IDAP REPORT

Property:	2 Woodward Avenue STRATHFIELD LOT:B DP:383091 DA2021.110
Proposal:	Demolition of existing structures, construction of a two (2) storey dwelling house, in-ground swimming pool and associated landscaping works.
Applicant:	H.A Design Group
Owner:	T Vuong & C Huynh
Date of lodgement:	31 May 2021
Notification period:	7 June 2021 to 21 June 2021
Submissions received:	NIL
Assessment officer:	G I Choice
Estimated cost of works:	\$1,078,242.00
Zoning:	R2-Low Density Residential - SLEP 2012
Heritage:	* Yes –The subject site is located within the <i>C17 - Woodward Avenue</i> HCA
Flood affected:	Yes
Is a Clause 4.6 Variation Proposed:	No
RECOMMENDATION OF OFFICER:	REFUSAL

Figure 3: Proposed ground floor plan

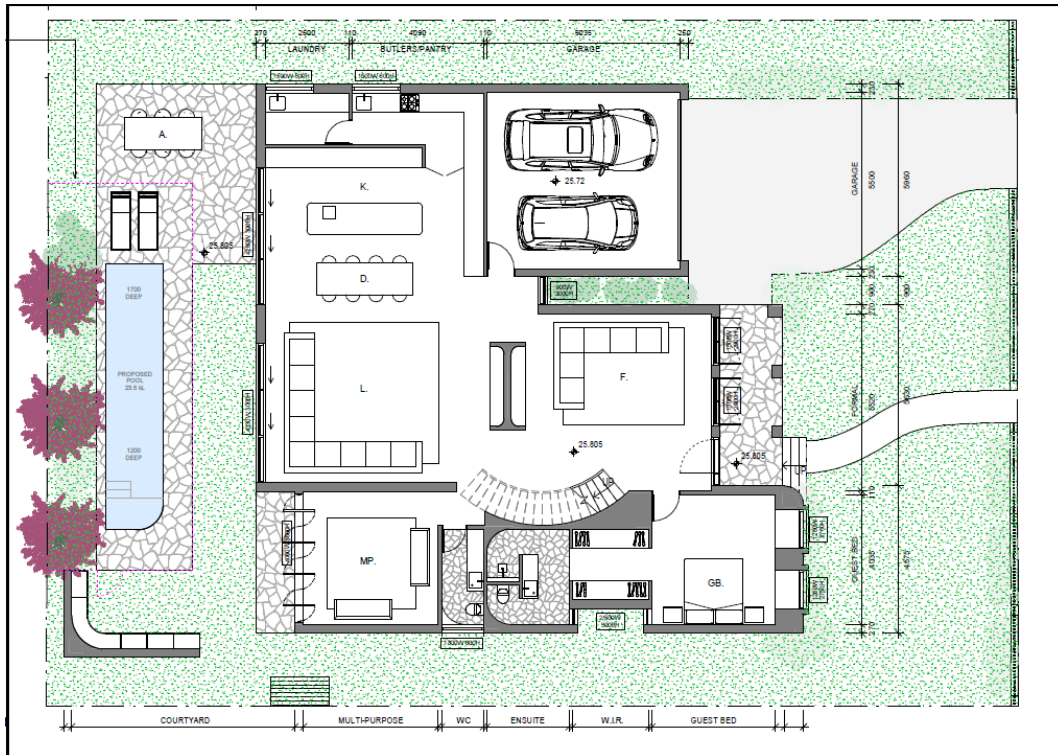
The proportions of garage door do not relate to the smaller and more vertical proportions of windows and doors found on the contributory buildings within the C17 HCA. The development has removed the driveway which led to a rear separate garage. The proposed new driveway, reduced side setback and double garage at the front of the property will result in a visually obtrusive design that does not reflect the pattern where the parking is located beside or behind the dwellings of the Woodward Avenue HCA. The garage is likely to dominate the site and erode the character of the streetscape.

Clause 5.3 of Part P requires new garages and carports to be located at the back or at the side of the house. Council advised that the proposed front façade garage should be setback further behind the building line so that it is not visually dominant from the street. This could include an increase of the western side setback to provide greater visual relief from the adjoining single-storey cottages to the west and accommodate a tandem carport or garage. A driveway consisting of wheel tracks with central grass/planting strip could replace the fully paved driveway space as a gesture to the existing streetscape.

Figure 5: Proposed north elevation

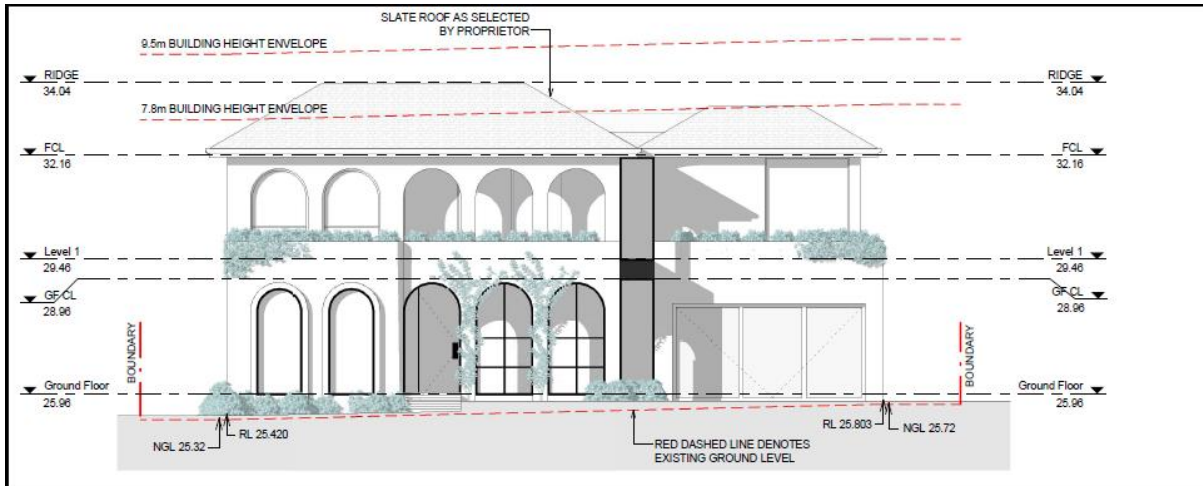
The proposed roof ridge height at 34.04 will sit above the existing two-storey dwelling at 95 – 97 The Boulevard (RL 33.81 to RL 33.93) to the east; and 4 Woodward Avenue (RL 32.83 to RL 32.85). In this regard, the proposed dwelling does not provide an appropriate transition between the two adjoining properties. Visual impacts to the Woodward Avenue streetscape would be further impacted by the proposed roof form and front façade which lack regard for the Victorian row of houses to the west. The proposed two-storey dwelling is inconsistent in scale when compared to the single-storey dwelling at the adjoining 4 Woodward Avenue. The proposed roof pitch of 20° is comparatively flatter than the pitched roofs within the HCA streetscape and presents an inconsistent scale which lacks regard for the adjoining streetscape, and will disrupt the rhythm of the prevailing roof form.

The proposed dwelling incorporates a series of arches at ground floor and first floor which is similar to the arch window at 95-97 The Boulevard. It is considered this presents as an isolated design feature which does not relate to the adjoining Victorian dwellings to the west. The repetition of arches is considered excessive and signifies a visual bias to the adjoining east dwelling.

It is considered the proposed two-storey dwelling design is unsympathetic to the existing HCA streetscape. The dwelling design has not adequately incorporated prominent building façade features of the existing streetscape which including roof shape, pitch and overhangs; fenestrations, colours and detailing; and the location and proportion of windows and doors.

Figure 24: Heritage referral streetscape analysis comments

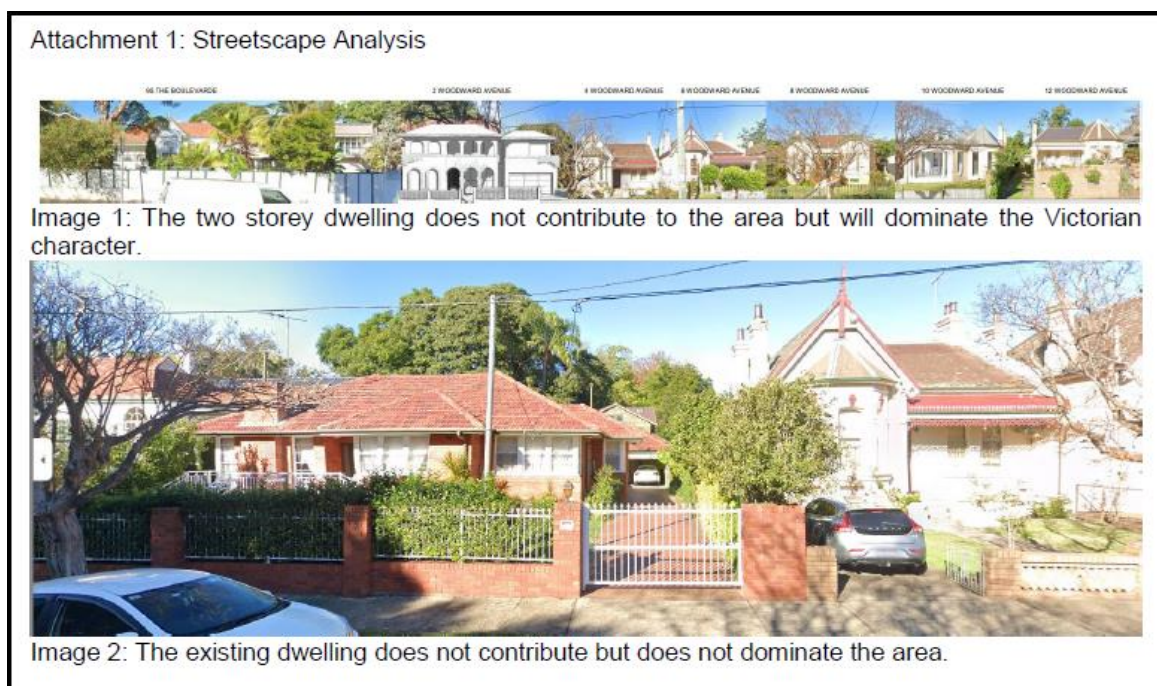
The proposal was referred to Council's Specialist Heritage Planner whom has determined that the height, bulk and the form of the proposed dwelling is intrusive and will impact on the adjoining row of Victorian contributory dwellings. The replacement of a single-storey dwelling with a two-storey modern Mediterranean style dwelling with a double garage and modern fence will diminish the existing character and streetscape in the immediate context of the HCA. The proposed two-storey dwelling cannot be supported as it does not satisfy the objectives of cl 5.10(1), specifically:

- *(b) to conserve the heritage significance of the heritage conservation areas, including associated fabric, settings and views.*
